**Options Appraisal for a Potential New
Settlement [CBRE] - Review**
East Devon Draft Local Plan 2020-2040

January 2023

- 1.1 This report has been prepared by **Turley** on behalf of **Bloor Homes South West** [“Bloor Homes”] and **Stuart Partners Ltd** to provide a review of the East Devon – Options Appraisal for a Potential New Settlement (CBRE, October 2022)¹ [“Options Appraisal Report”].

Image EDP 3: Extract of Appendix A Map 9 – Landscape sensitivity for housing, overlaid with revised Option areas – black = Option 1, yellow = Option 2 and blue = Option 3.

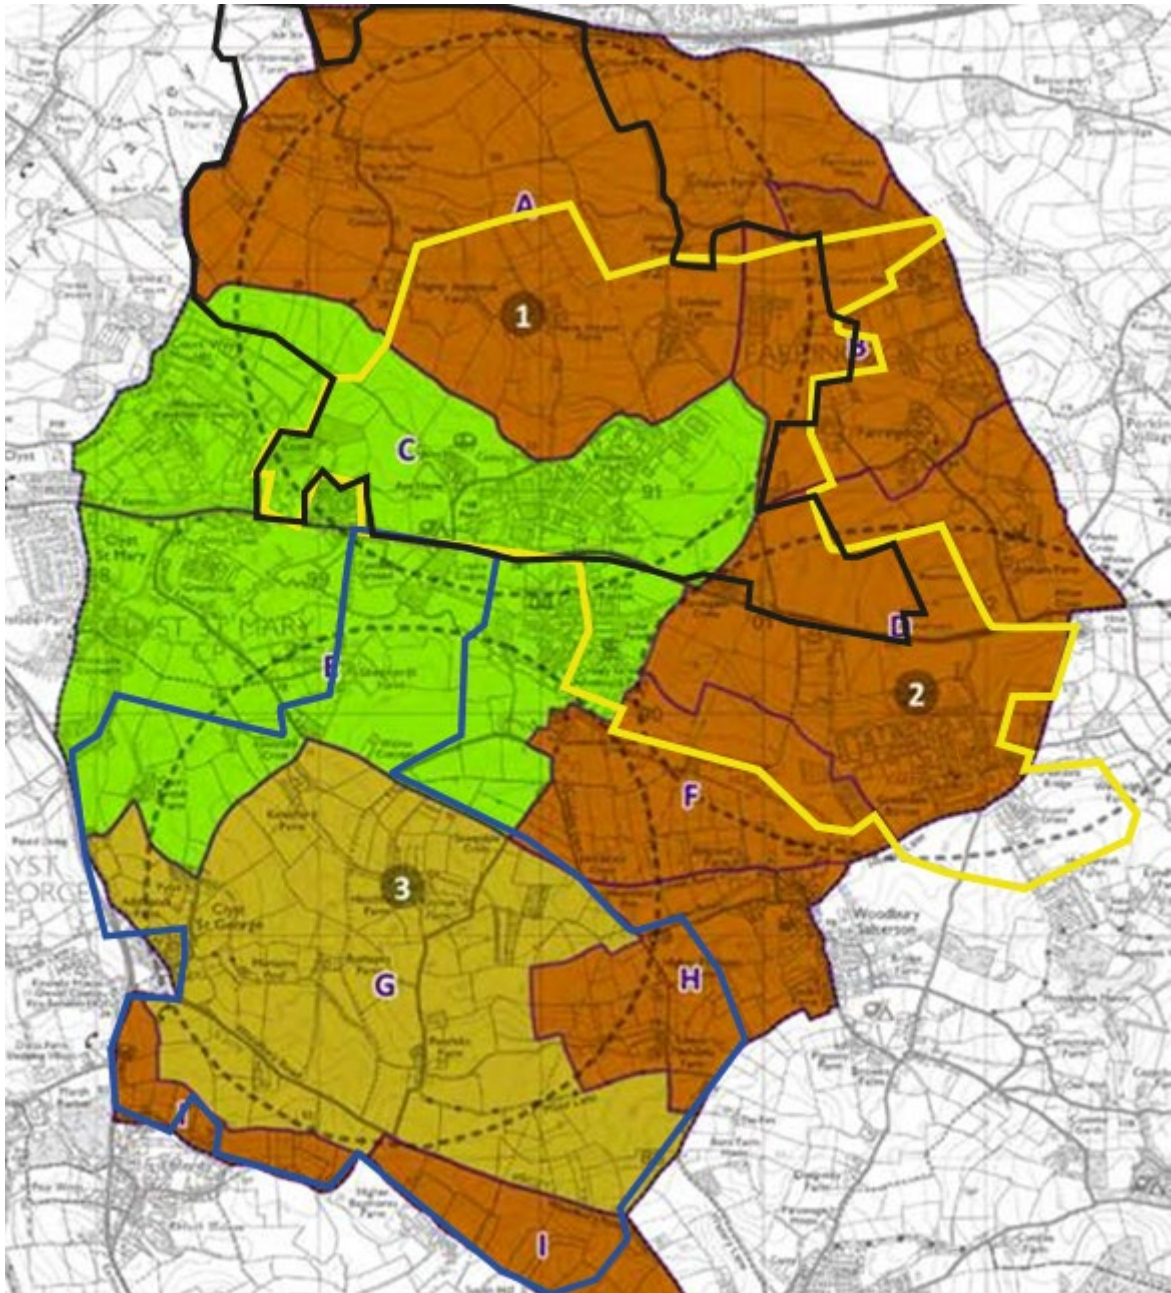
7. In terms of the comparison between Option 1 and Option 3, both share the central area of Medium-Low sensitivity (for residential), and it is the LLUs to the extreme north and south (A and G respectively) where the differential lies – see Map 9 of the LA, repeated below as **Image EDP 3**. LLU A (covering a large part of Option 1) has a High-Medium sensitivity with LLU G (covering a large part of Option 3) having a Medium sensitivity;

8. Ultimately the difference between the two options (Options 1 and 3) appears marginal, and results from the above difference between LLUs A and G. Based upon a review of the baseline information presented in the LA, these two LLUs are broadly similar in terms of topography, designated sites, priority habitats and historic landscape character, so it must be assumed that localised experiential differences lead to the marginal higher sensitivity for LLU A. It is also true that Option 1 sits further away from the Area of Outstanding Natural Beauty (AONB), which lies to the south-east, and is perhaps not given sufficient prominence in the appraisal in this respect. An overlay of the LLUs and the option areas is provided as **Image EDP 3**; and

9. In terms of how these scores translate into the CBRE report, Option 3 has an overall evaluation of '3', with Options 1 and 2 having an overall evaluation of '2'. Whilst this difference is considered to be marginal (and probably within the realms of subjective judgement) on the basis of the review herein, it is considered entirely feasible that Options 1, 2 and 3 could all potentially have an overall scoring of 2 or 3.

Figure 1: Areas for potential residential development (source ACT Acoustics Noise Assessment (ref 170613–225))

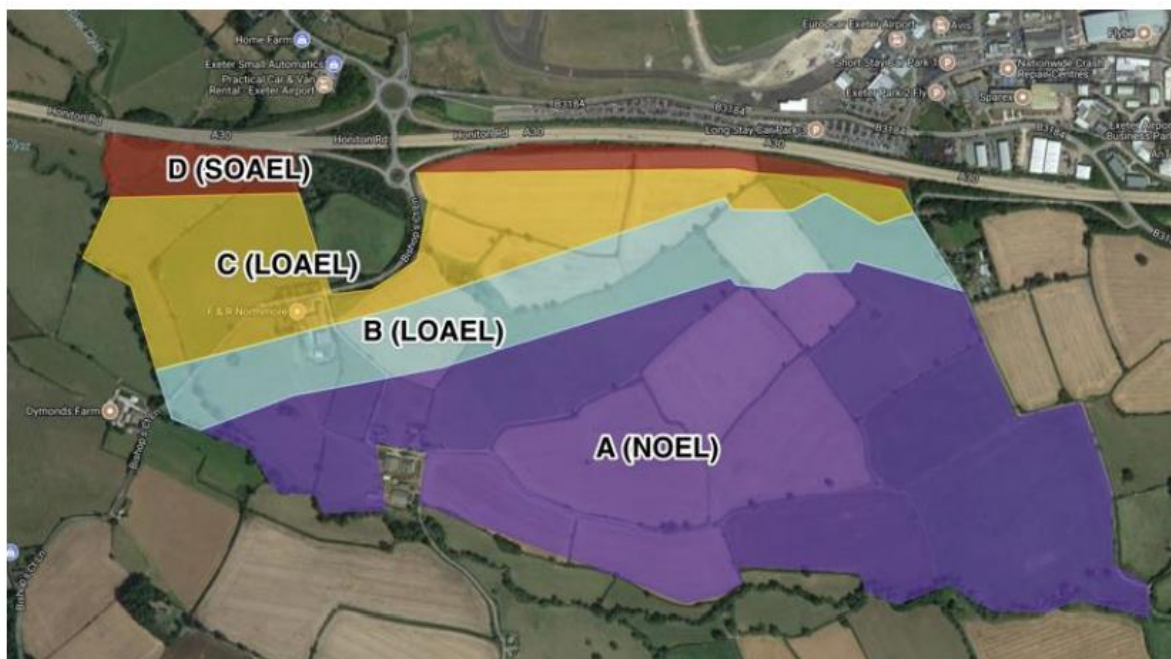
3.3.10 As Figure 1 shows, the majority of land south of the A30 and Exeter Airport is developable. The masterplanning process could ensure a stand-off from the A30 and Exeter Airport is incorporated to minimise residential development within Noise Bands C and D. Development within Noise Band B could be designed to ensure a robust building envelope design.

Figure 3.1 – Cranbrook Masterplan as included as Figure 8 of The Cranbrook Plan

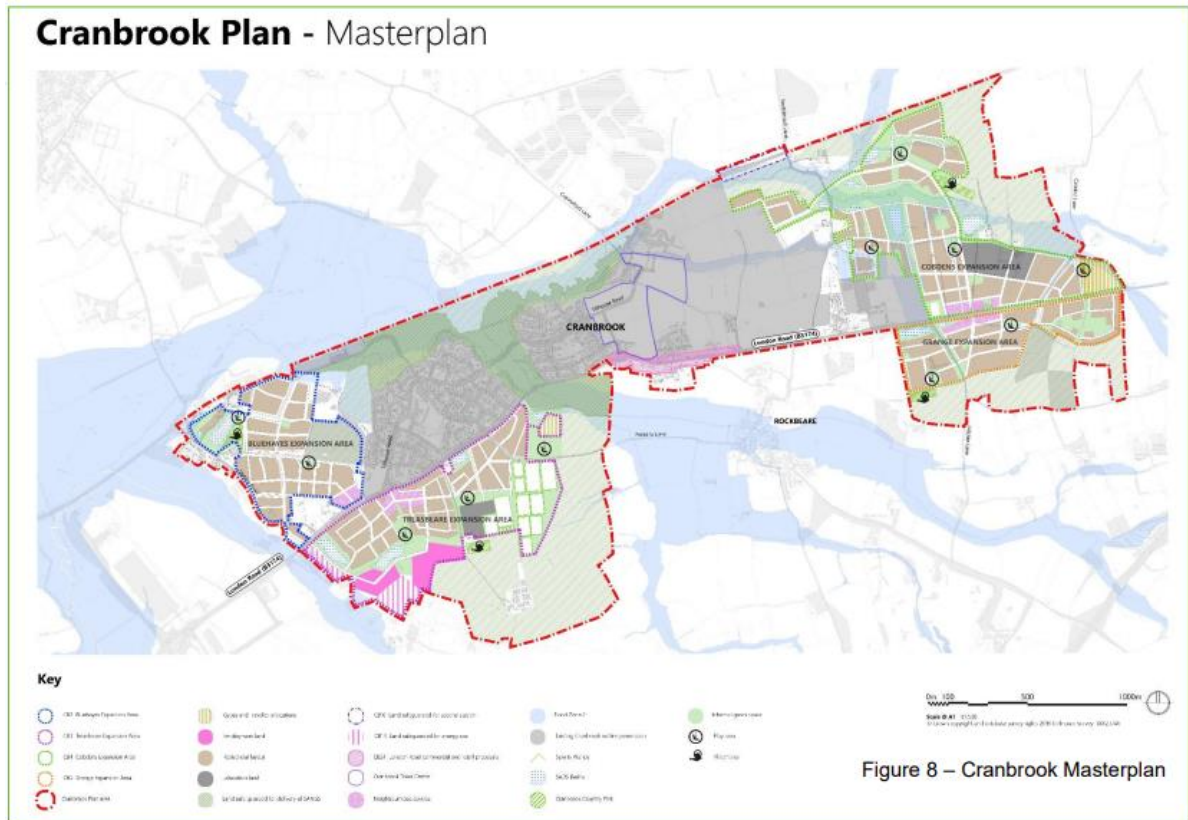
3.1.5 It is however recommended that further consideration should also be given to planned proposals that would also introduce further facilities within walking distance of a proposed community. For instance, no discussion is currently provided within the Hydrock Report in relation to the committed growth at Cranbrook which would also introduce a local centre, education, and employment facilities within a walkable distance of the Option 1 site. Details of these proposals are set out in **Figure 3.1** below that provides an extract of the masterplan as included as Figure 8 of The Cranbrook Plan adopted by East Devon in October 2022. Linkages through to these proposals are already provided via the B3184 A30 overbridge and Clyst Honiton Bypass / London Road and these committed facilities would be accessible from a reasonable walking distance (typically identified as 2km) from a large area within the north of Option 1.

Figure 3.2 – Comparison linkages to Exeter north of Option 1 site with NCN 2 connection linking with Option 3

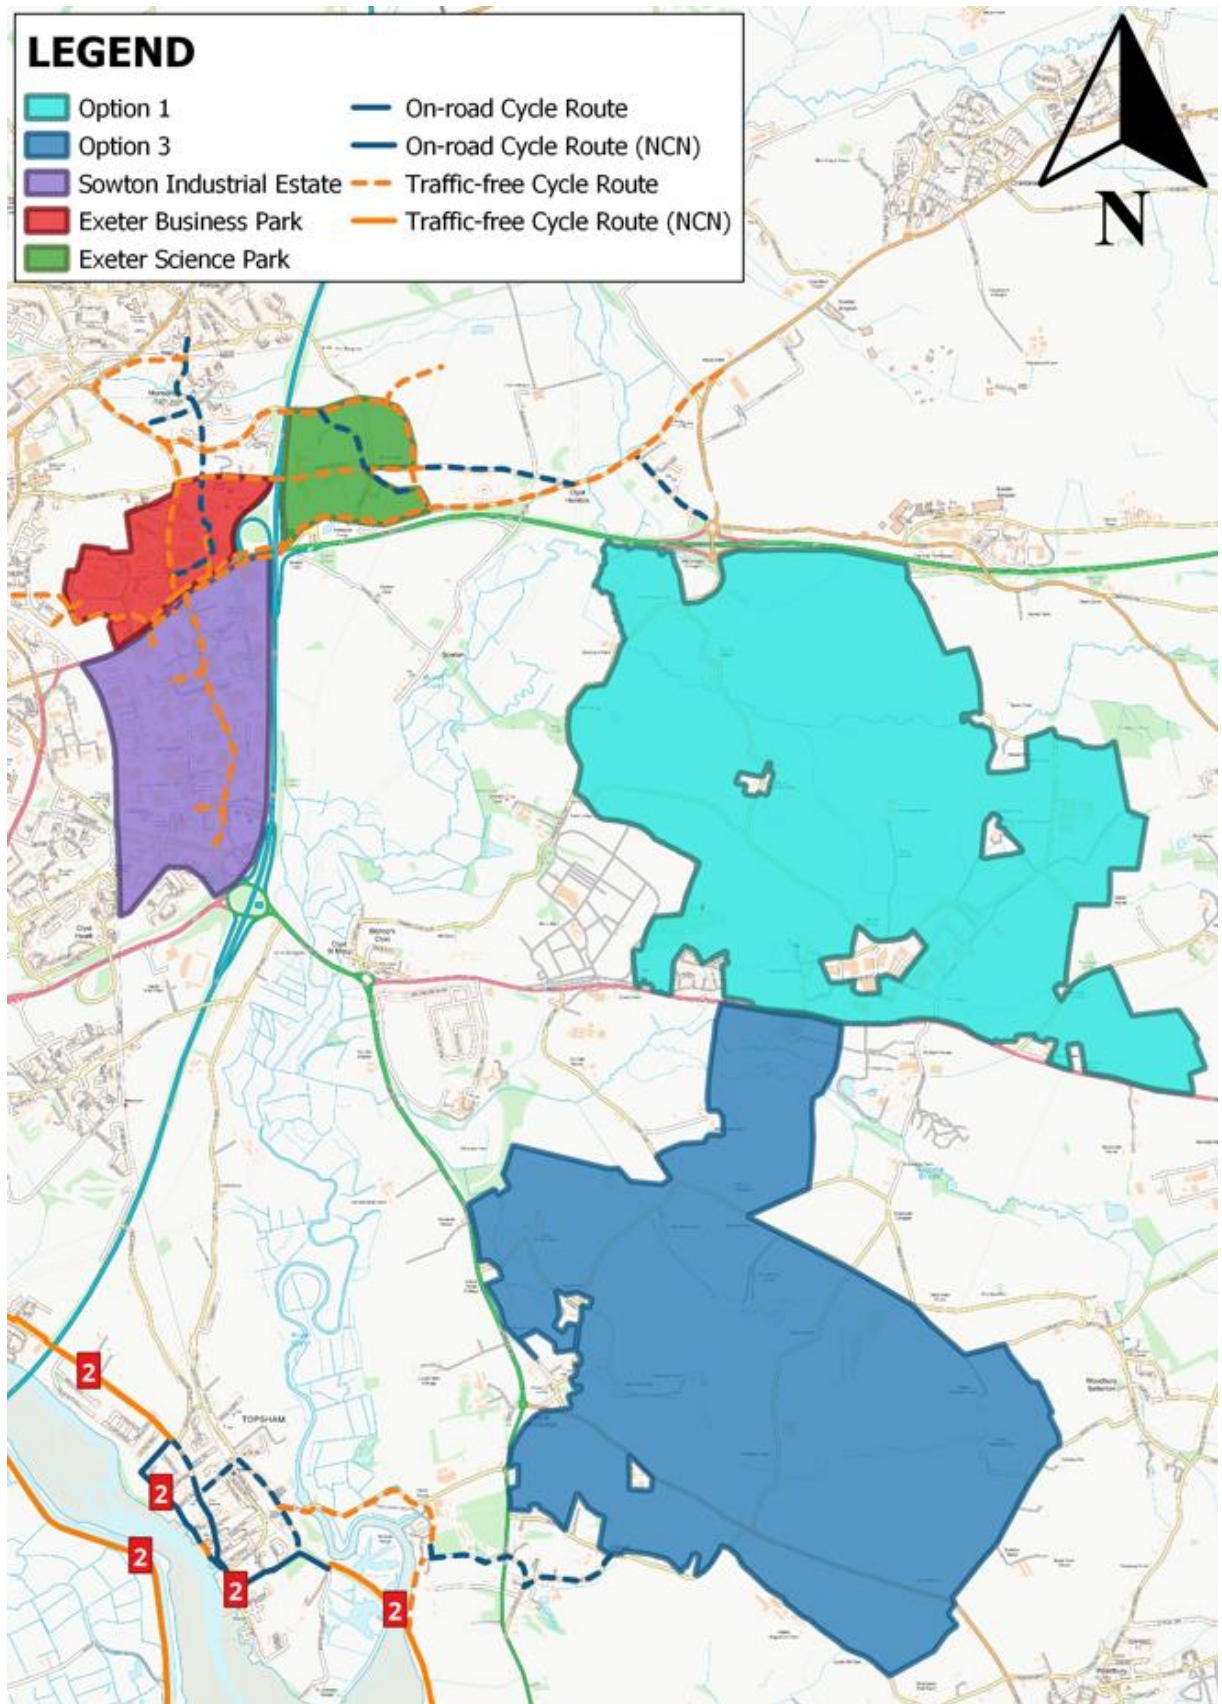
- 3.1.8 **Figure 3.2** below sets out the cycle routes across the M5 from the Option 1 site via Honiton Road. This includes a route which continues along the road and crosses the M5 via signalised crossings at the Junction 29 underpass, as well as an additional route that continues along Blackhorse Lane before crossing the M5 via a segregated active travel link and bridge just north of Junction 29. These routes provide a connection with Exeter via a 3km cycle from the Option 1 site and are easily accessible via Bishops Court Lane and the A30 overbridge. Moreover, the routes also provide a connection with Exeter Science Park, Exeter Business Park, and the Sowton industrial estate representing key employment areas both within and on the outskirts of Exeter.

- 3.1.9 Contrastingly the connection to Exeter from the Option 3 site via NCN 2 (also shown on **Figure 3.2**) is longer (almost 4km). Furthermore, the point of connection is also a residential area with no key destinations nearby that would likely provide a key draw for cyclists. Thus, it appears that the advantages of this route could be overstated especially when compared to connections to the north linking with the Option 1 site.
